APPENDIX E: DEVIATION FROM OPERATIONAL PLAN FORM, DESECHEO NWR

Requested by	David Will	Change #	1
Topic	Cliffs	Date submitted	3/16/16

Cliff gorges
areas
21.2 ha

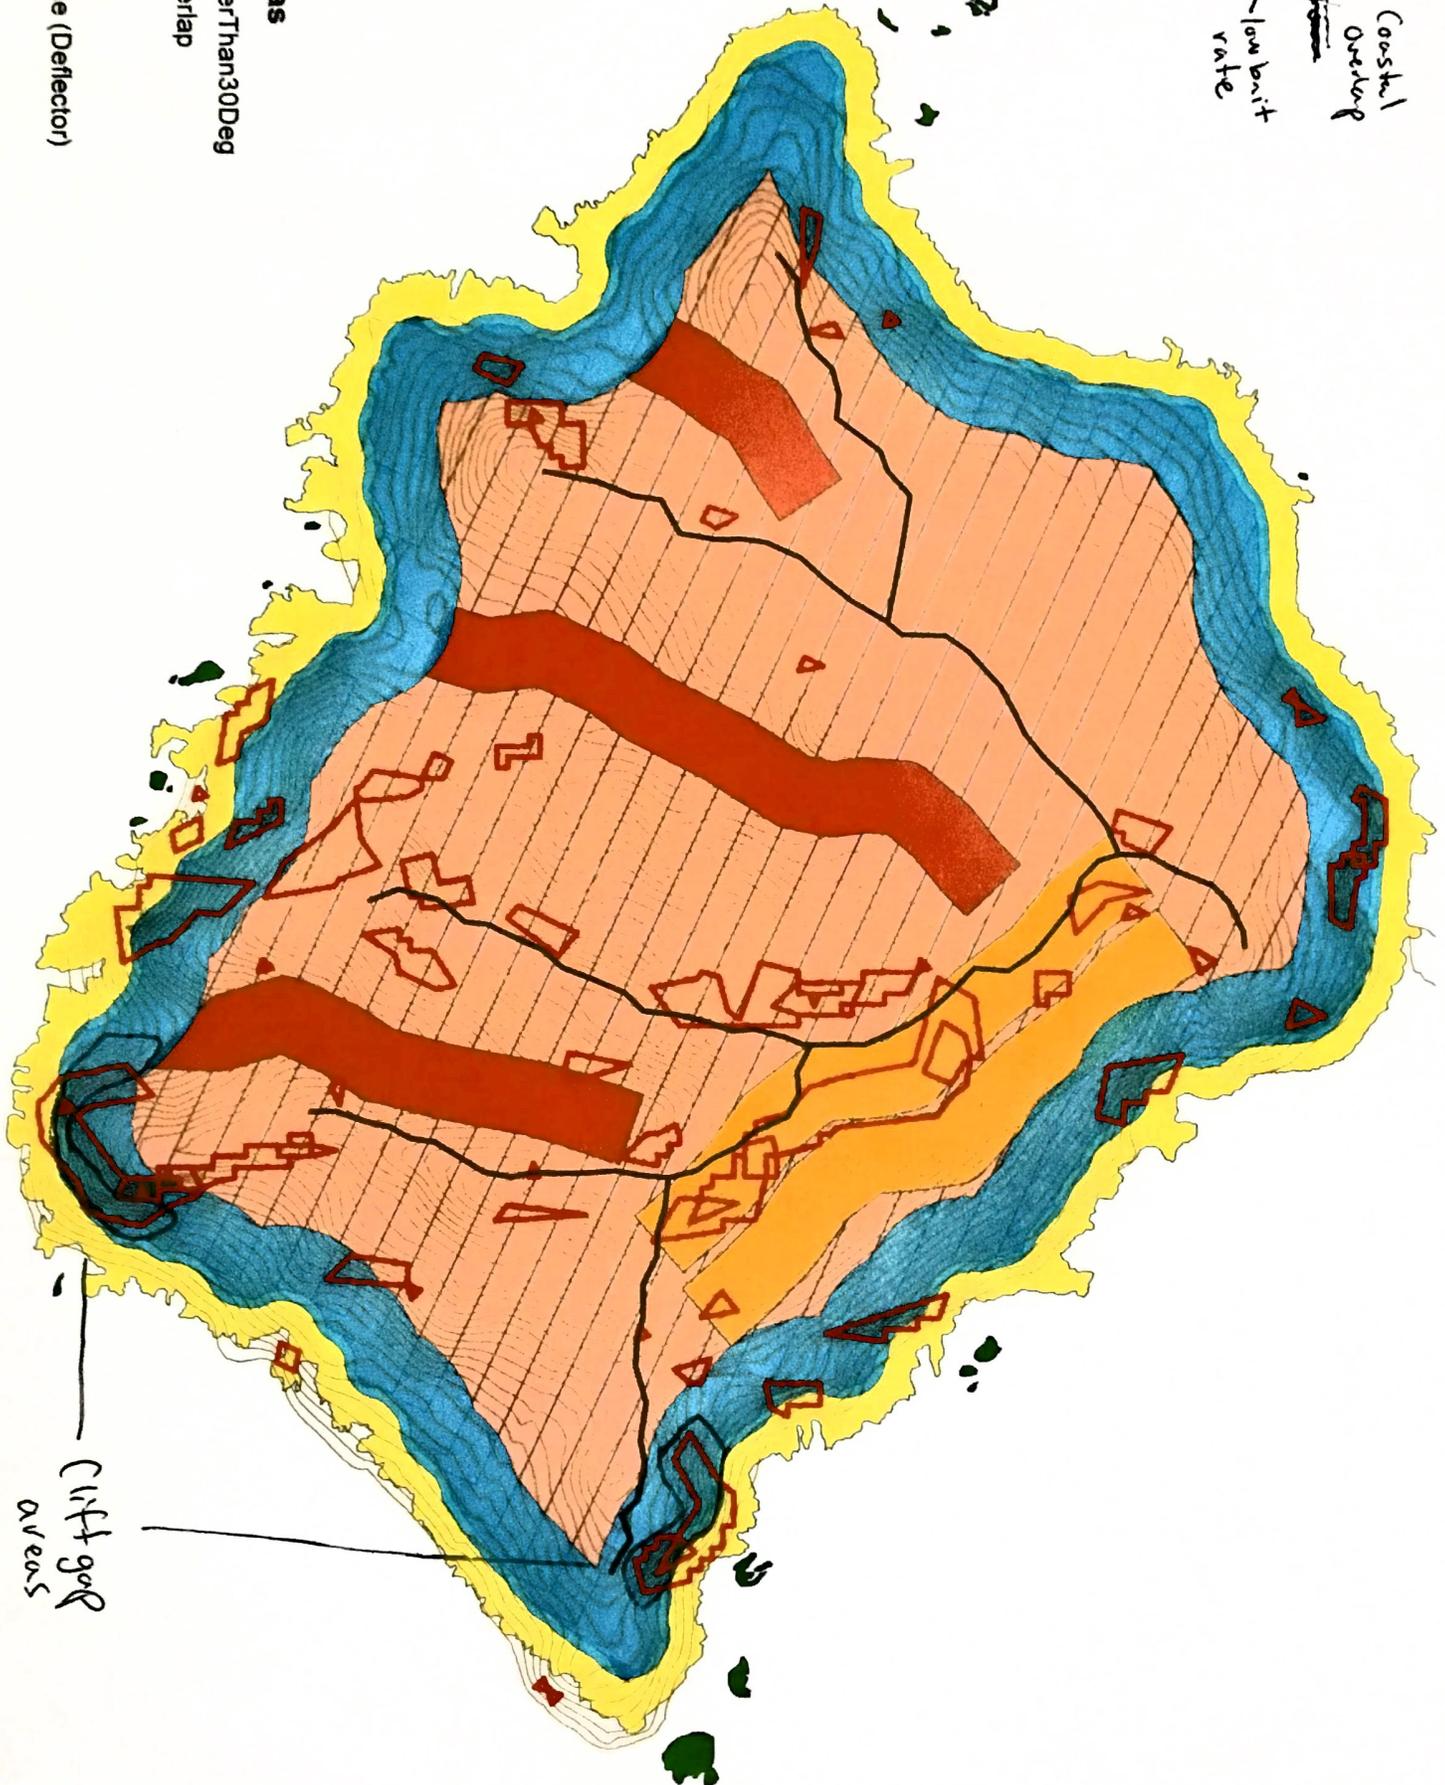
~~Two~~ Two cliff areas will be treated at a median height area w/ a deflector bucket @ 17kg/ha. The steep nature of these cliffs makes treatment by full swath difficult and bait will be shadowed and at less than target rate, resulting in gaps.

Label allows for treatment of cliffs & areas below target application rate. Sheer slope of cliffs means that deflector is sown at bottom & full swath at top leaving small amount of bait at middle of cliff. Proposed change treats a gap at the rate described for cliff faces.

Effect on Non-target Risk, Efficacy, and Project Cost		
Non-target Risk	Efficacy	Project Cost
/	Increases efficacy by reducing areas of low application rate.	/
